From: [Roland Lebrun](#)
To: [Perez, Raul](#)
Subject: Fw: Downtown West DEIR comments
Date: Thursday, December 10, 2020 5:15:56 PM
Attachments: [Downtown West DEIR comments.pdf](#)

Further to my November 22nd 2019 scoping comments <https://www.sanjoseca.gov/Home/ShowDocument?id=65095> (page 69), thank you for the opportunity to comment on the Downtown West DEIR with the introduction of a station configuration alternative designed to eliminate conflicts, including the requirement to demolish the Southern Pacific depot Main Building Landmark.

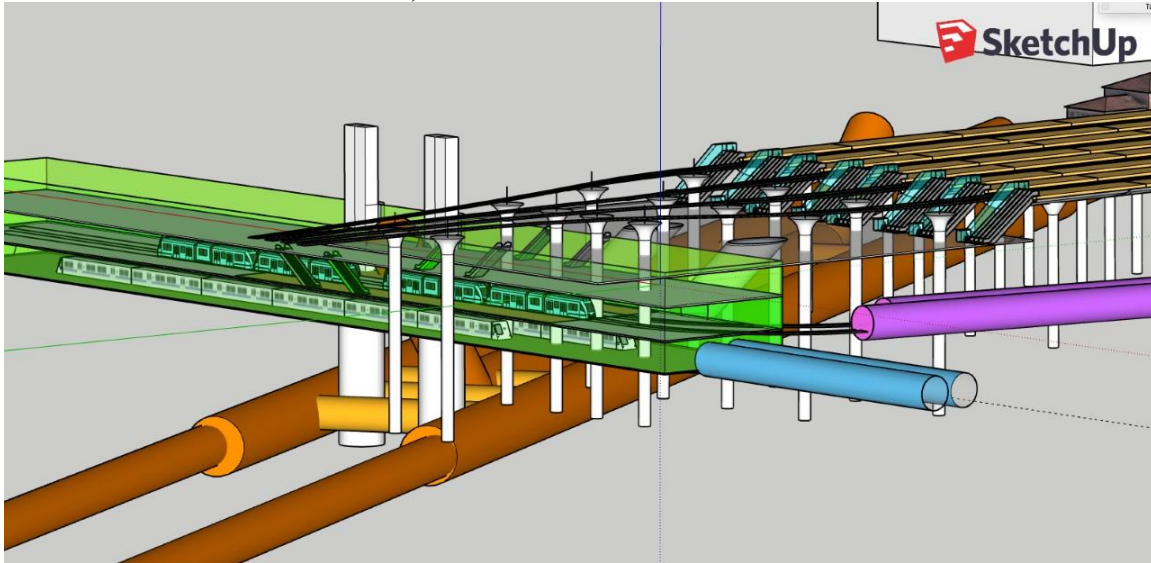
The proposed elevated station will have 6 main entrances (3 on each side):

- Santa Clara (public transportation)
- Paseo de San Fernando (active transportation)
- Park (private transportation)

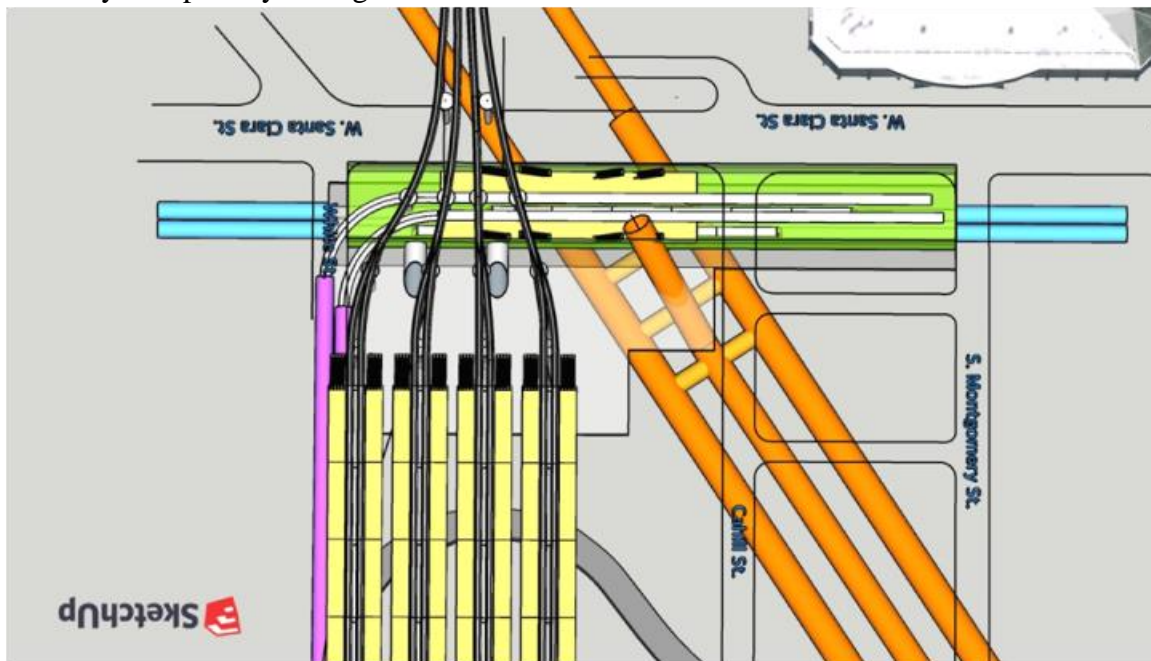
Construction phasing will start with the relocation of the light rail tracks to a tunnel (purple) between Sunol and White Street to the light rail (yellow) platforms located between the concourse and the BART (green) platforms (this configuration is similar to the MUNI Embarcadero station).

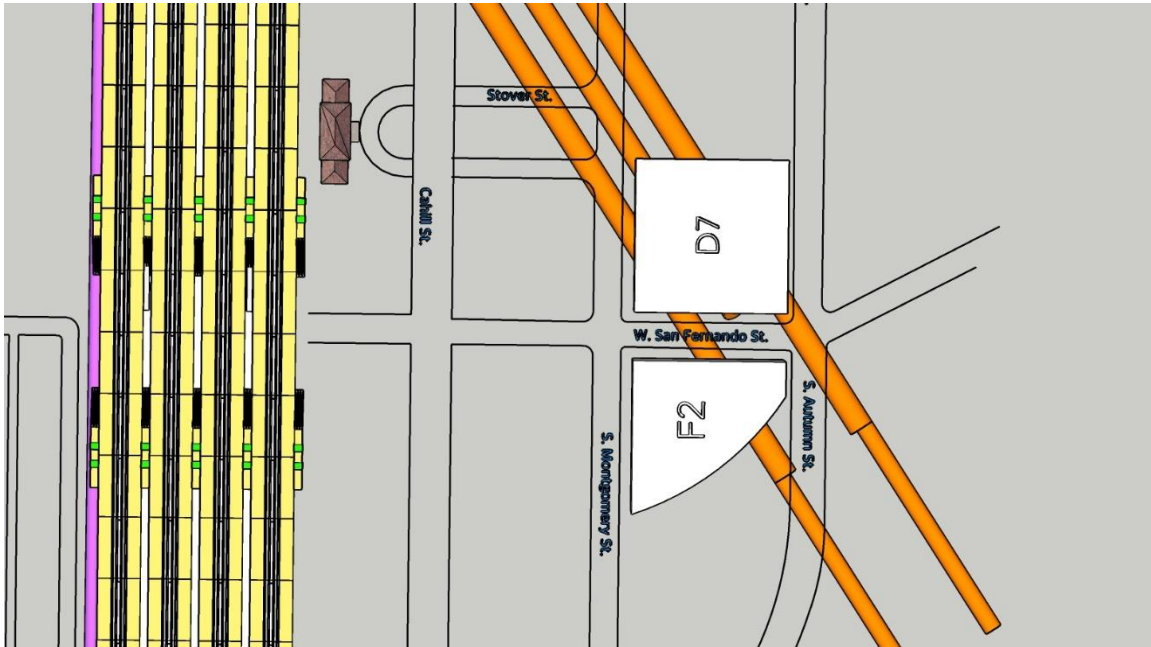
Next, the two west-most heavy rail tracks and platforms will be raised above the area currently occupied by the light rail station and tracks.

Please note that the extended heavy rail platforms will be centered between Park and West Santa Clara to eliminate conflicts with Parcels A, B & C. Additionally, the number of elevated station tracks will be reduced from 10 (or 11 as currently proposed) to 8 to eliminate throat expansion(s) beyond the existing right of way.
